CARRIER, MAINTENANCE, FULL TRACKED, MKs 1 AND 1/1 FV434

GENERAL INSTRUCTION NO. 1

SUBJECT: EMER TV E 109/4 Miscellaneous Instructions No. 1 to No. 8

Fig 1 - Oil, filter bracket

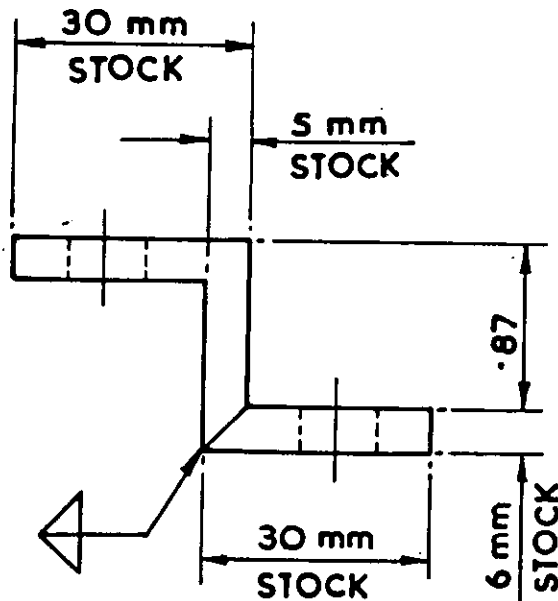
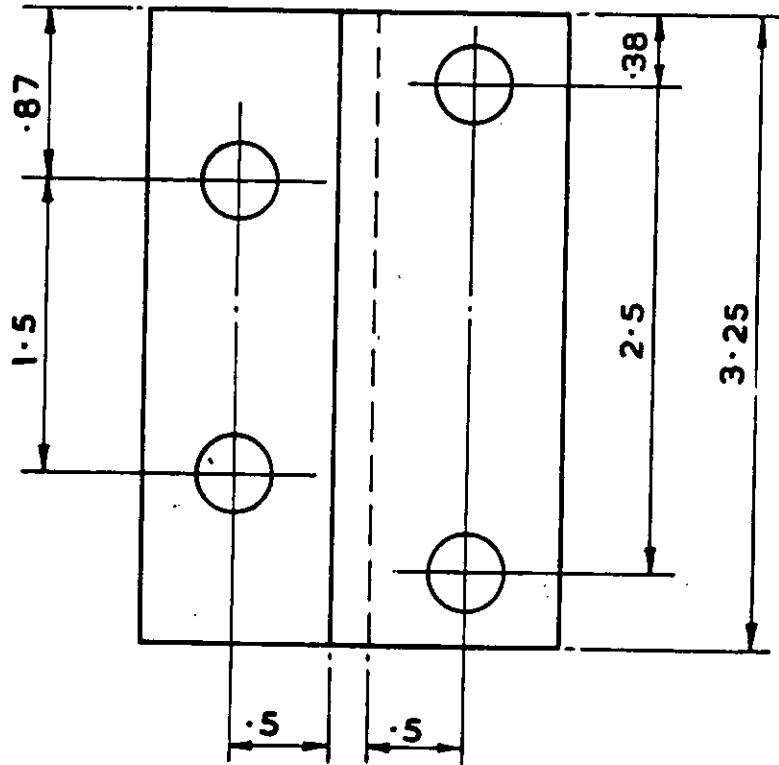
1. The original oil filter is now out of production and is replaced by oil filter Part No 6MT1/4330-99-524-2681.

a. When the new type oil filter Part No 6MT1/4330-99-524-2681 is fitted, a bracket is to be manufactured as detailed in Fig 1 using local stores.

b. The bracket is to be fitted on to existing filter securing studs and the new filter on to the bracket.

Fig 1 Front towing eye

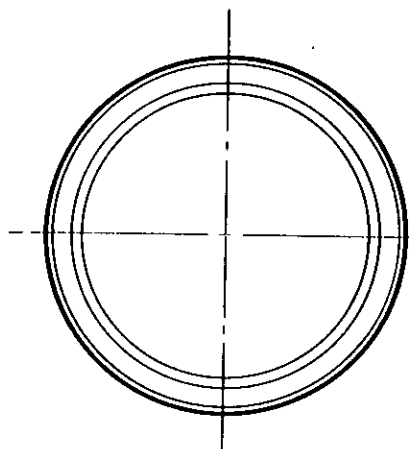
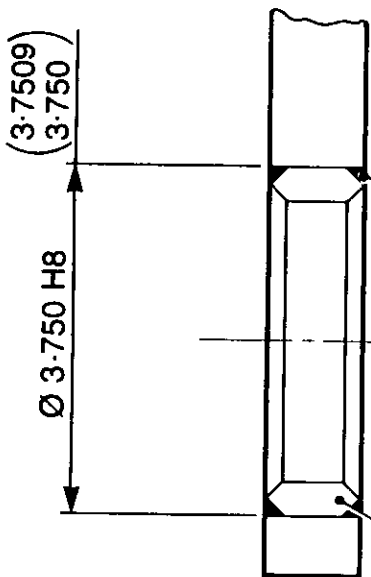
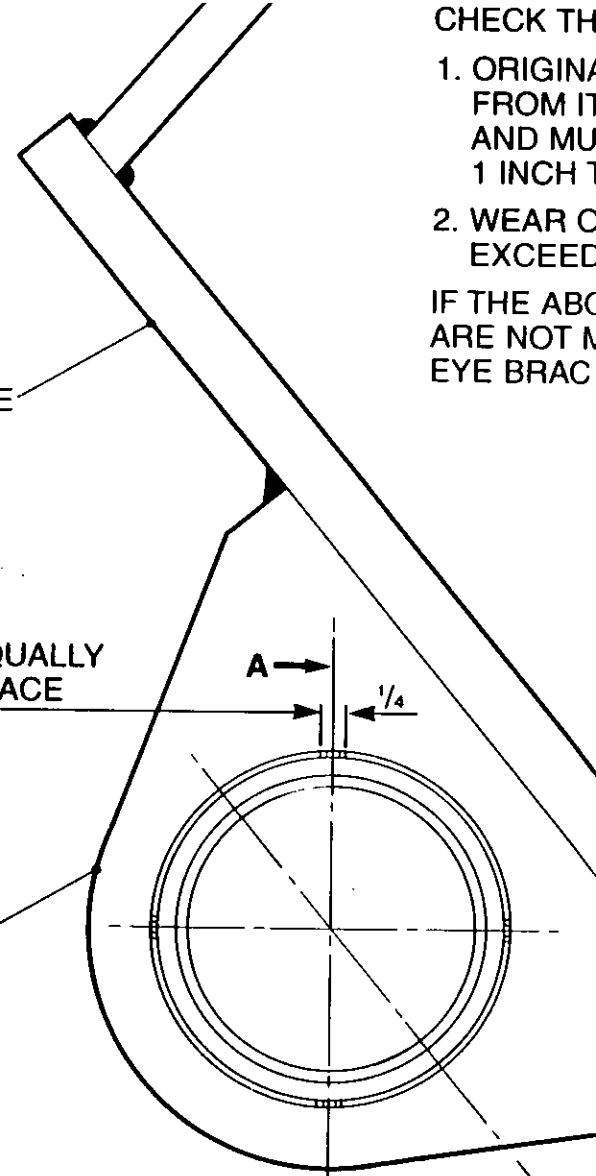
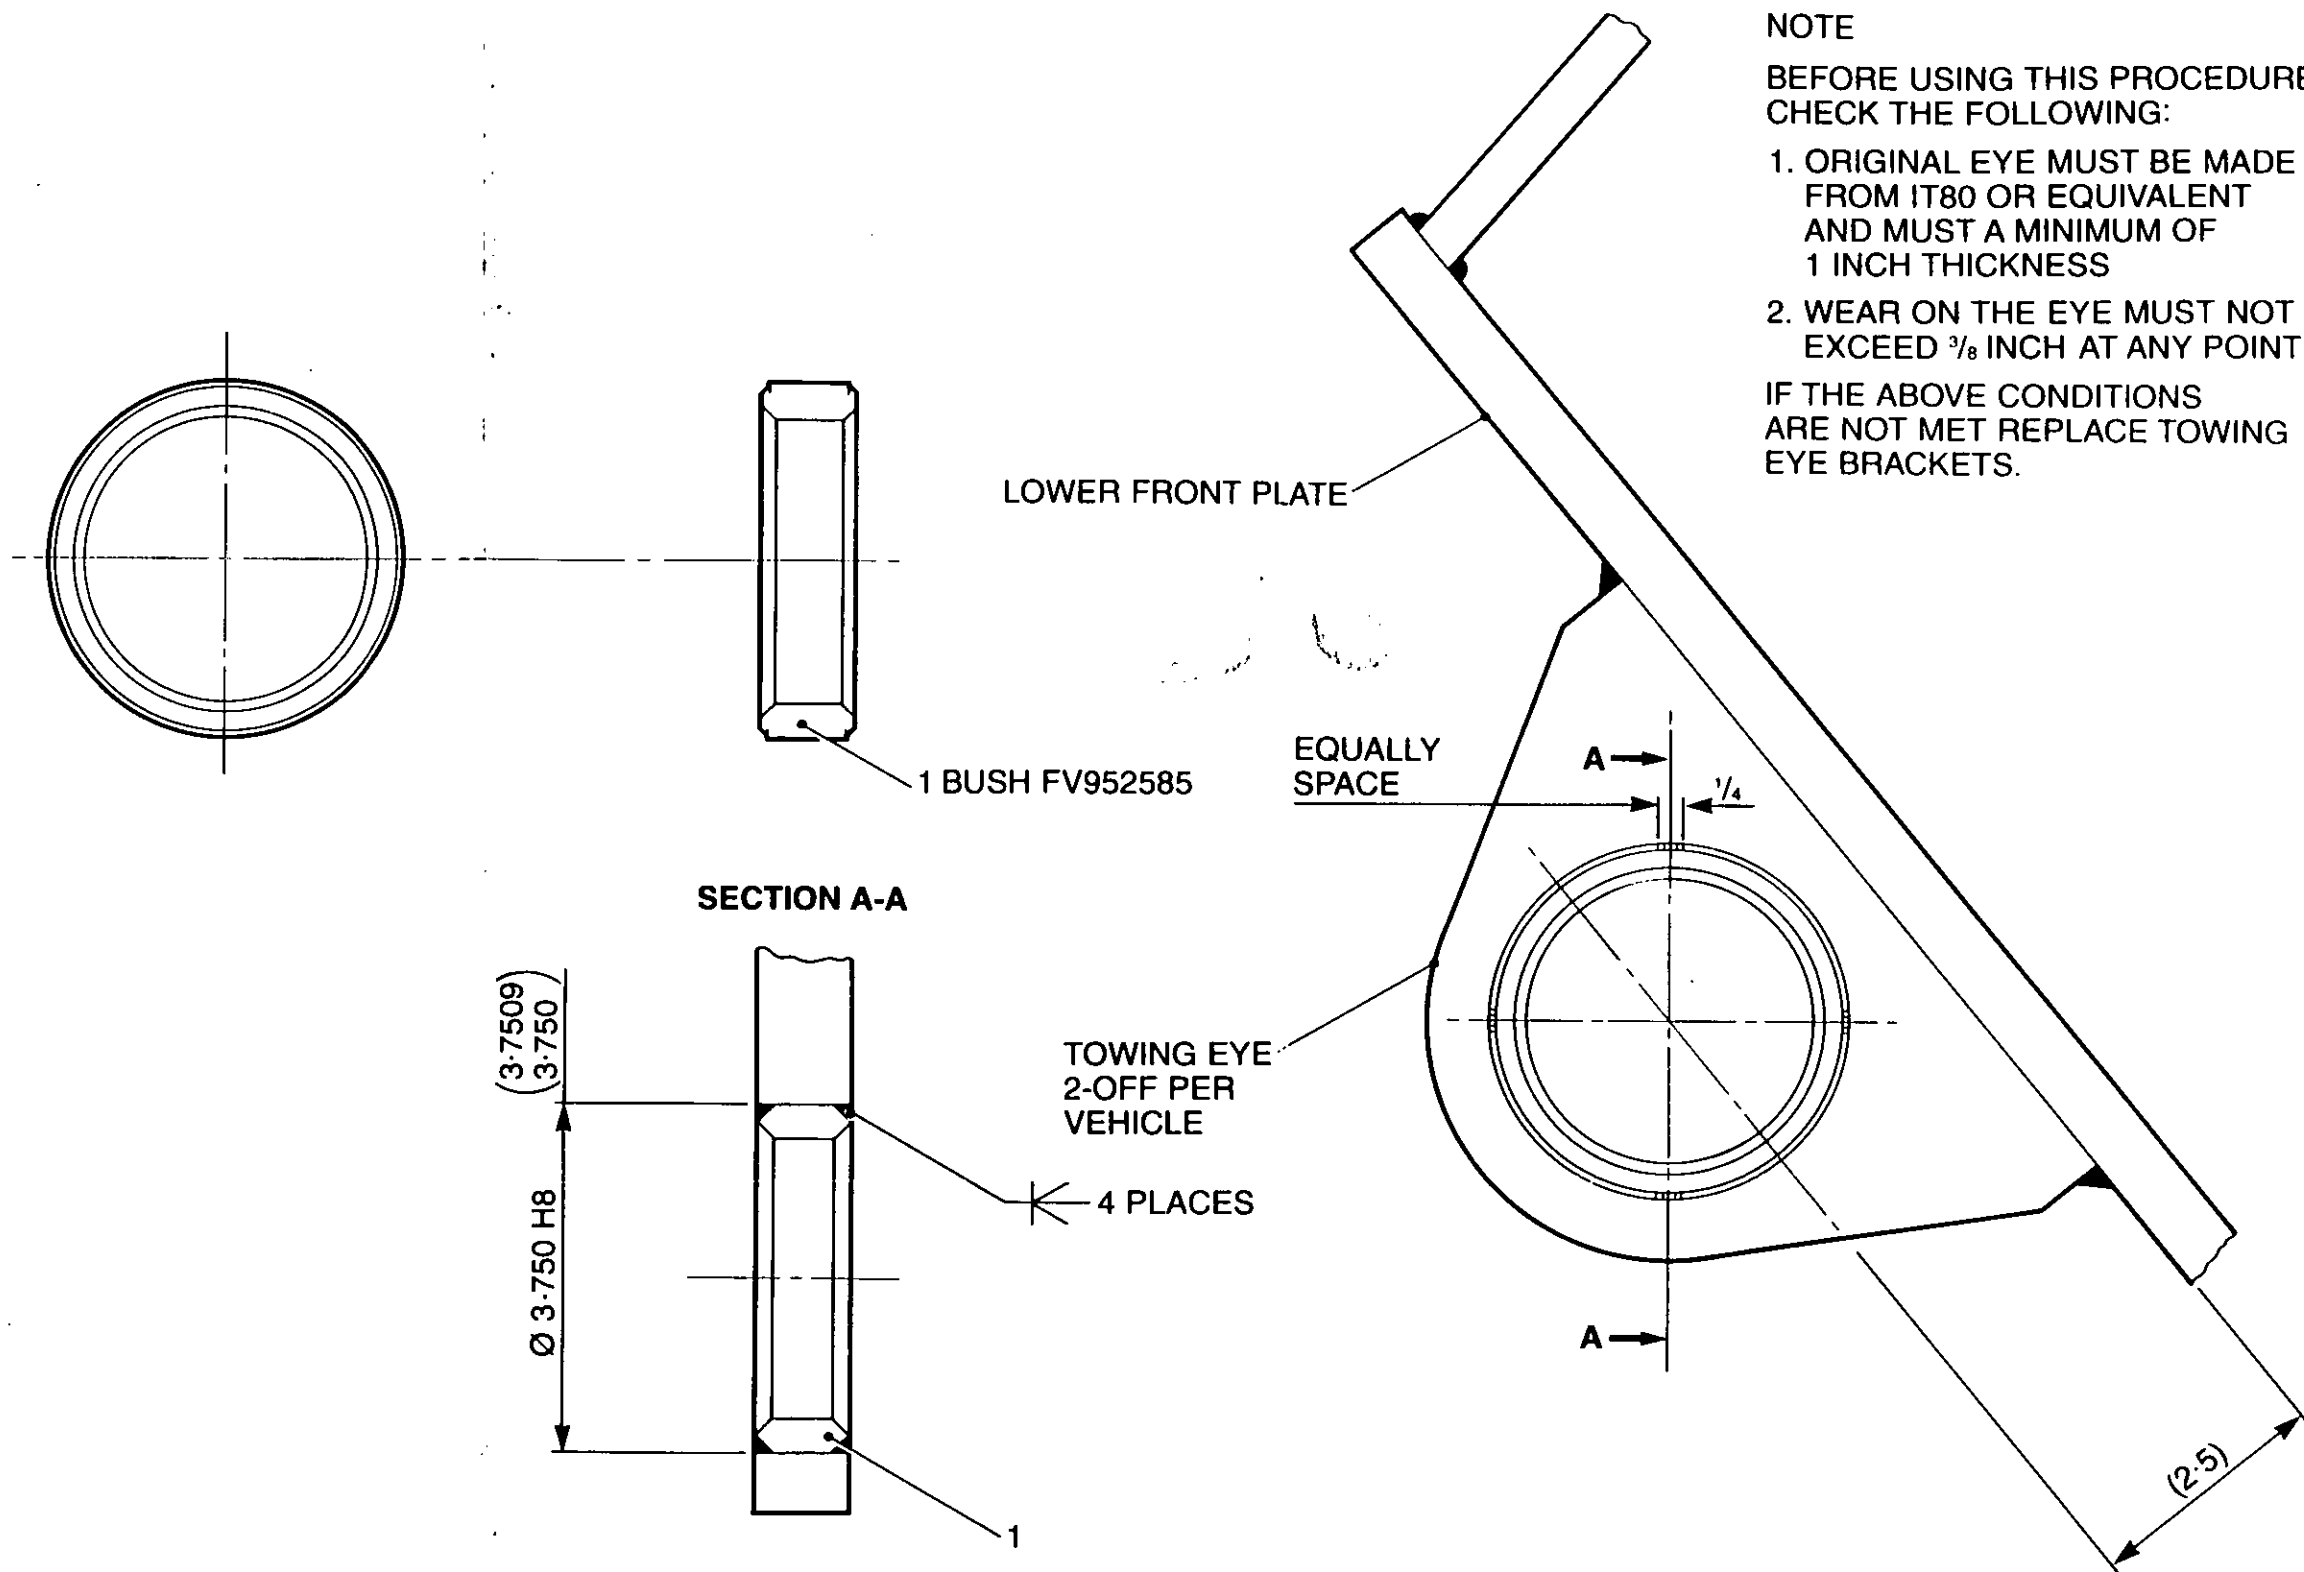
9.1 When the front towing eyes are within repairable limits:

9.1.1 Bore eyes to dimensions shown in Fig 1 and tack weld in each new bush in eight places as shown.

- 9.2 When one, or both front towing eyes are outside repairable limits:
- 9.2.1 Cut off both front towing eyes to within 6 mm of armour plate.
 - 9.2.2 Remove remaining metal by grinding, avoid overheating of armour plate.

NOTE
BEFORE USING THIS PROCEDURE
CHECK THE FOLLOWING:
1. ORIGINAL EYE MUST BE MADE
FROM IT80 OR EQUIVALENT
AND MUST A MINIMUM OF
1 INCH THICKNESS
2. WEAR ON THE EYE MUST NOT
EXCEED $\frac{3}{8}$ INCH AT ANY POINT
IF THE ABOVE CONDITIONS
ARE NOT MET REPLACE TOWING
EYE BRACKETS.

RECLAMATION PROCEDURE:
1. DRILL OUT TOWING EYE AS SHOWN
2. ASSEMBLE BUSH - DETAIL 1
3. TACK WELD TO SECURE

Fig 2 Rear towing eye

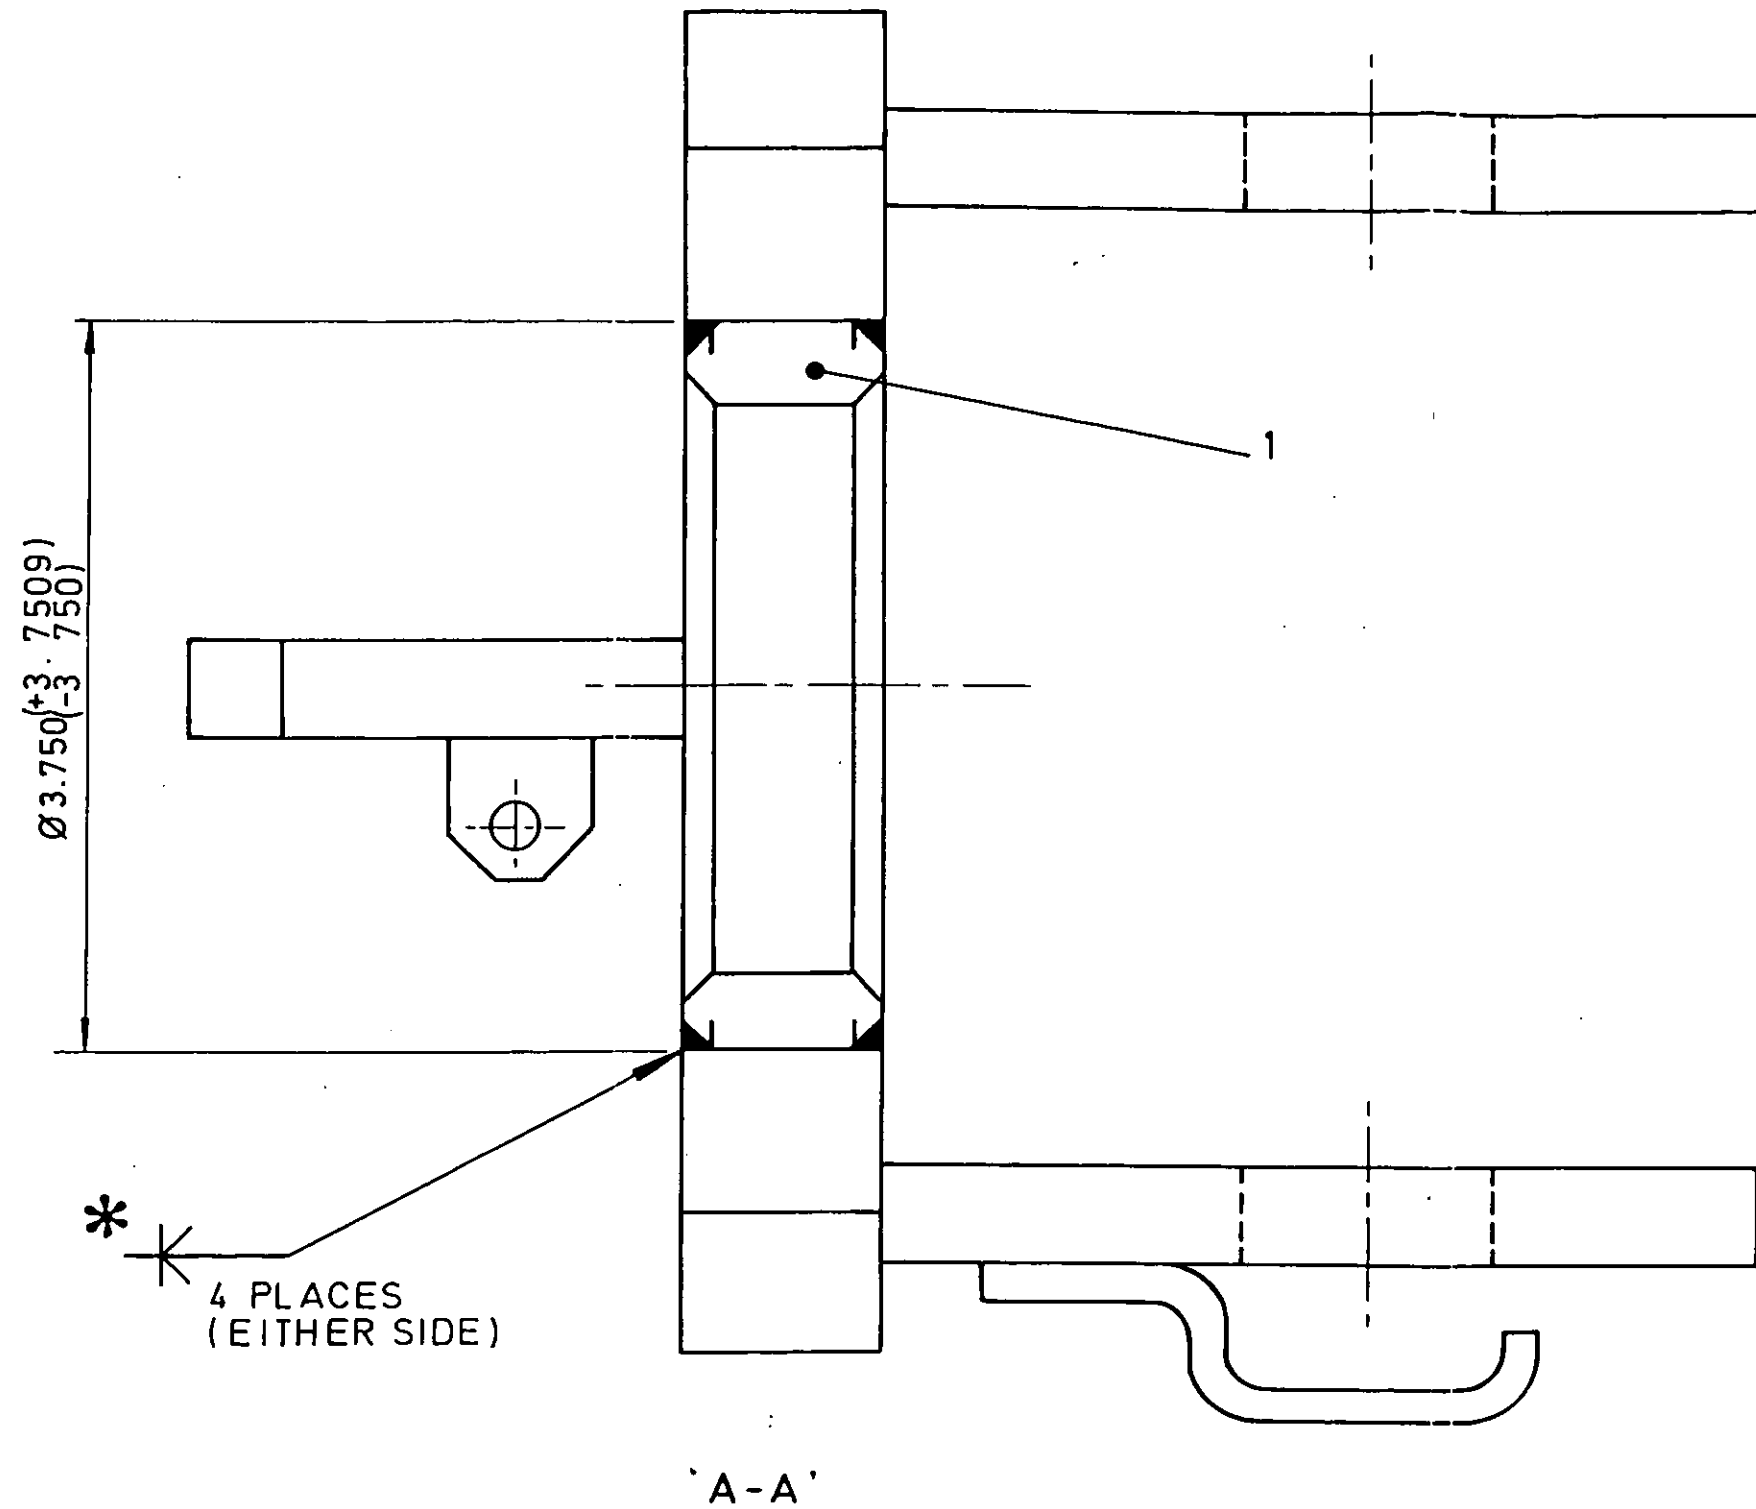
- 9.3 When one or both rear towing eyes are in repairable limits:
- 9.3.1 Bore eyes to dimensions shown in Fig 2, and tack weld each new bush in eight places as shown.

NOTE :-
TACK WELD TO SECURE AT *

Fig 1 Replacement of the front access cover hinges (hatch), set from the hull hinges

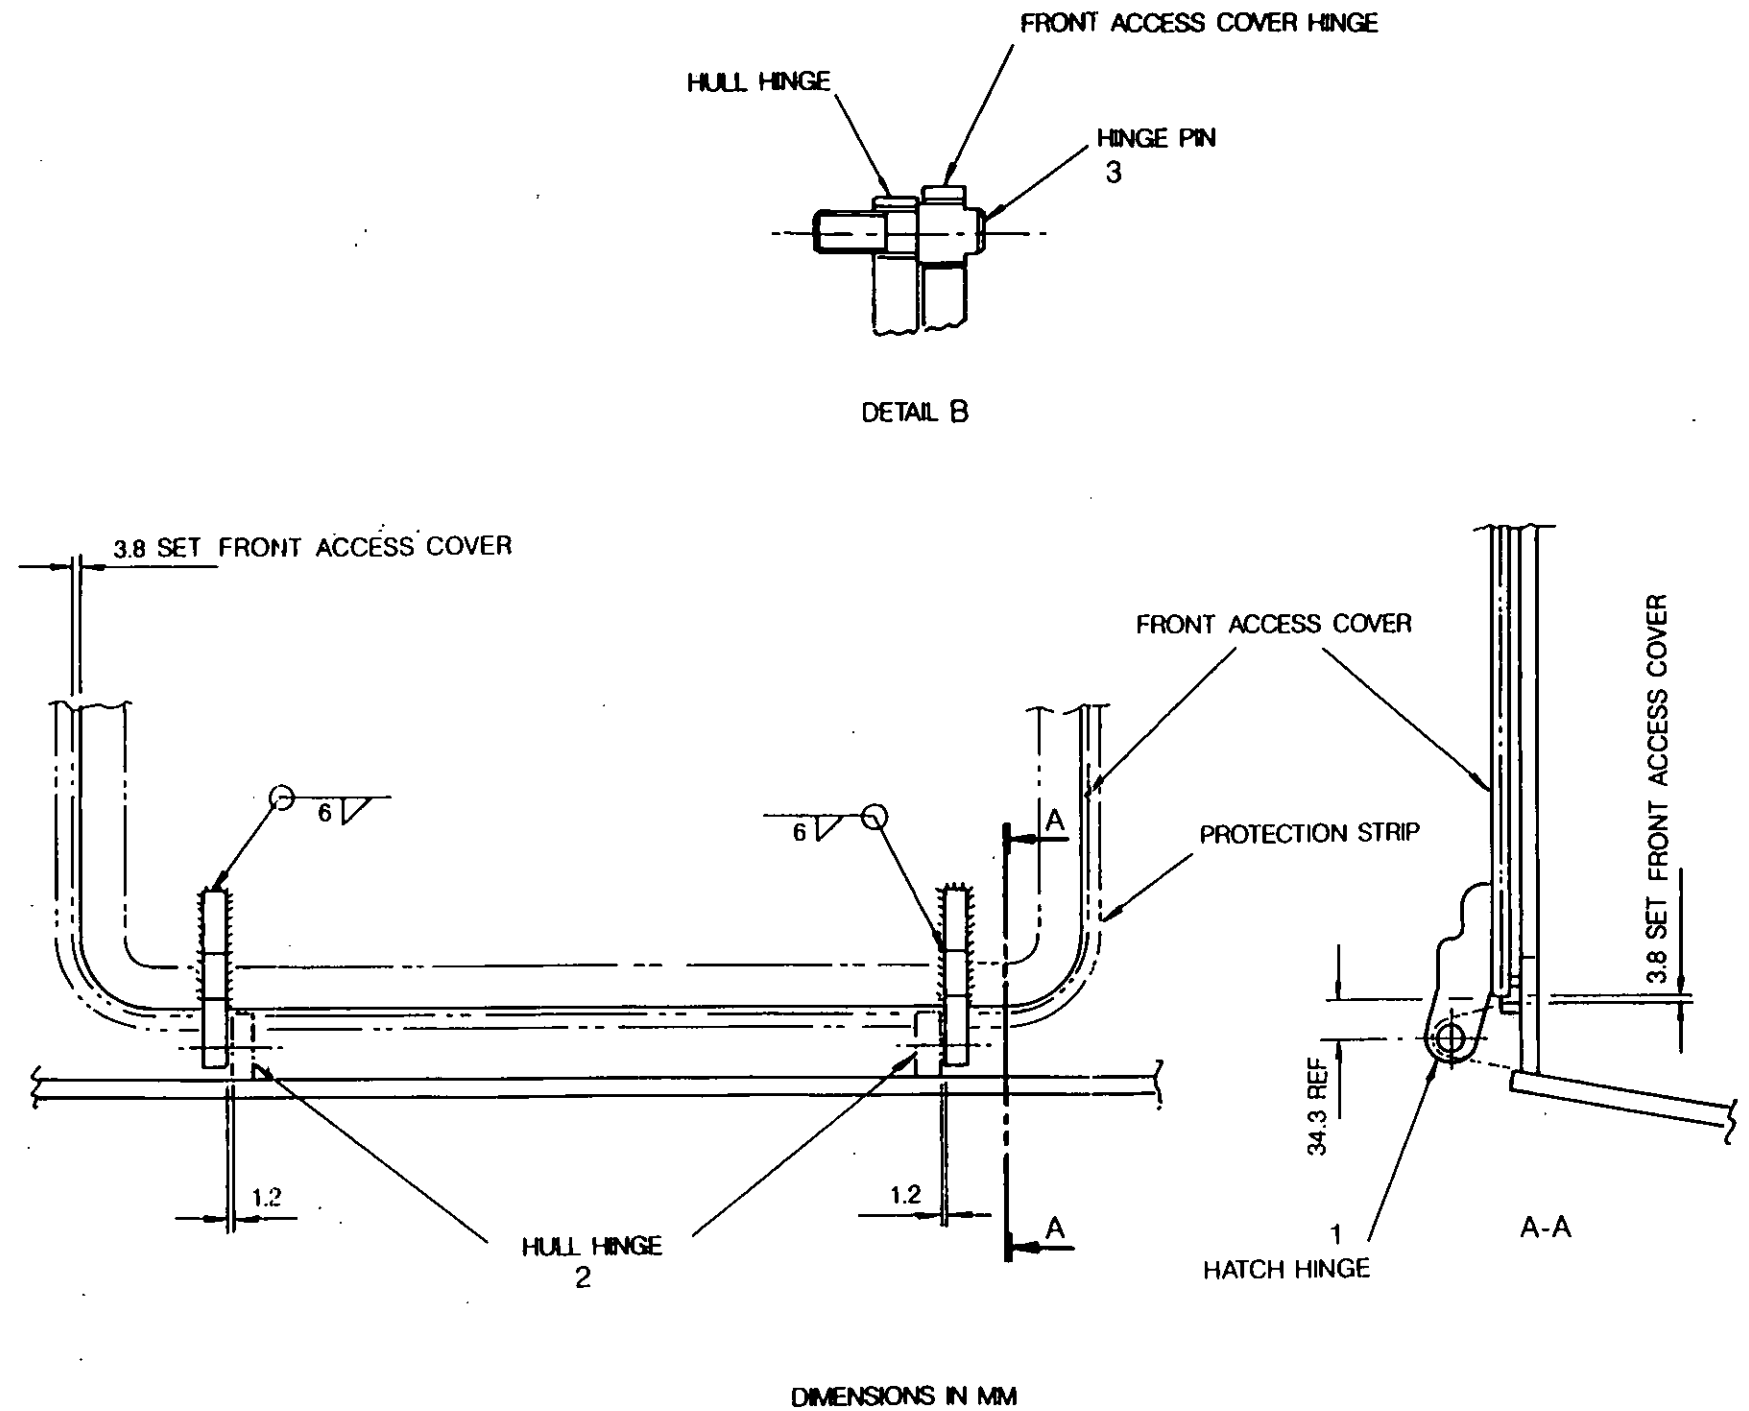
9.1 To replace the front access cover hinges (hatch), follow the repair scheme detailed at Fig 1.

- (1) This scheme is to be used when hinges on front access cover assembly are replaced.
- (2) Welding is to be carried out to EMER Wksp O 360 Chap 12, using a 3.25 mm rod.
- (3) Before commencing with repair, remove front access cover from the vehicle.

- 1 Remove existing access cover hinges by gas cutting or gouging within 6 mm of armour plate.
- 2 Remove remaining metal by grinding. Avoid overheating of armour plate.
- 3 Finish smooth armour plate and use NDT (penetrant dye) to establish that no surface cracks are present.

- 4 Locate front access cover on vehicle and set to 3.8 mm from inside edge of protection strip and clamp in position.
- 5 Set first front access cover hinge to 1.2 mm from first hull hinge and align hole centres using hinge pin (item 3). Make initial root weld along bottom edge of hinge and cover.
- 6 Set second front access cover hinge to 1.2 mm from second hull hinge and align hole centres using hinge pin (item 3). Make initial root weld along bottom edge of hinge and cover.
- 7 Check accuracy of hinge for position and squareness and use hinge pin (item 3) to ensure clearance when pivoting. See detail 'B'.
- 8 Unclamp front access cover and remove from vehicle.
- 9 Complete welding of front access hinges as shown.
- 10 Inspect.
- 11 After 72 hours, check with NDT that welds and plates are crack free.
- 12 Finish to DEF STAN 03-32 Part 2, colour as per contract.
